## RE: DLE IDI-ORO FACILITY: RFQ Supply of Bolt & Gasket for DL2516

**From** Olabode Oke <olabodeoke@dormanlongeng.com>
**Date** Wed 8/5/2026 2:00 PM
**To** Agnes Ajiere <agnesanyanwu@dormanlongeng.com>; Fidelis Owan <fidelisowan@dormanlongeng.com>; John Ochigbo <johnochigbo@dormanlongeng.com>; Olamilekan Alabi <olamilekanalabi@dormanlongeng.com>
**Cc** Temitope Odulate <temitopeodulate@dormanlongeng.com>; Chris Ijeli <chrisijeli@dormanlongeng.com>; Cletus Bassey <cletusbassey@dormanlongeng.com>; Uduak Esau <uduakesau@dormanlongeng.com>; Charles Ihuarulam <charlesihuarulam@dormanlongeng.com>; DLE Finance <dlefinance@dormanlongeng.com>

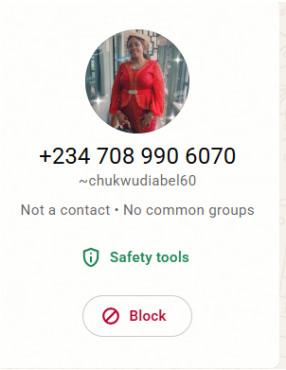
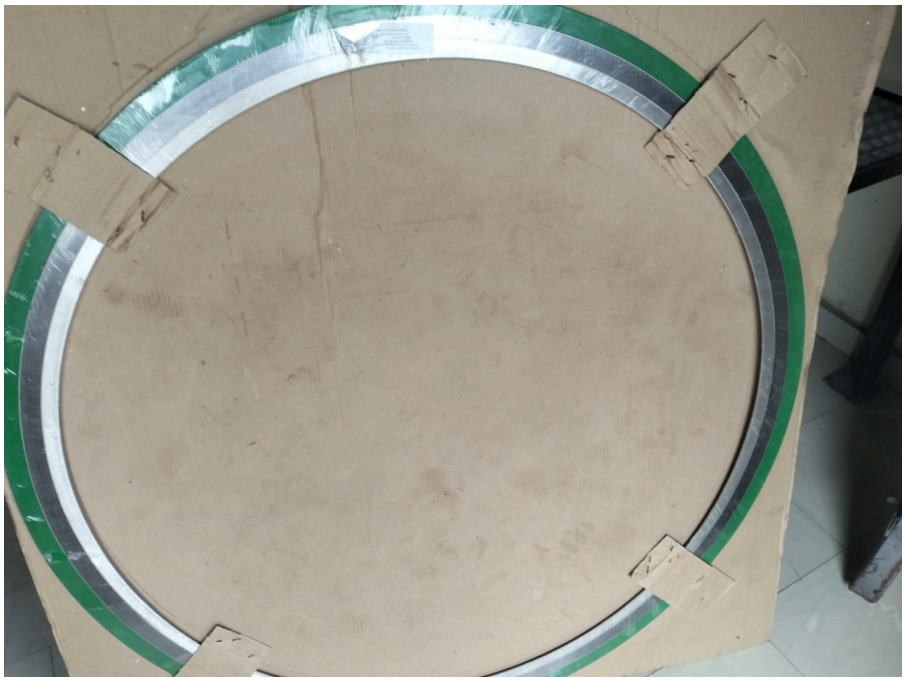
Dear Bode,
The thread though rusted were still running the Nut threads.
For your Proposal to use it as it is, the Bolt shall be cleaned and re-inspected individually before dispatch.

Thanks. We discussed yesterday that it is going to be used inhouse. Because of the urgency, please confirm if the treading were worn-out or rusted, but can still be cleaned and greased for use.

Dear Bode,
The inspection was completed on 01/08/26. The Gasket and the washers are acceptable, But the Stud bolts and Nuts are recovered and not acceptable.

Dear Uduak,
As discussed yesterday, following the review conducted to verify the suitability of the recovered bolts by checking the nut run, we understand that the bolts are acceptable for use.
Based on your review and approval, we will proceed with the procurement of the required nuts and mobilize them to site to facilitate the planned hydrotest.
Kindly let us know if there are any further requirements or observations.

Please go ahead and engage him for the cleaning and re-inspection for the purpose of use. Thanks
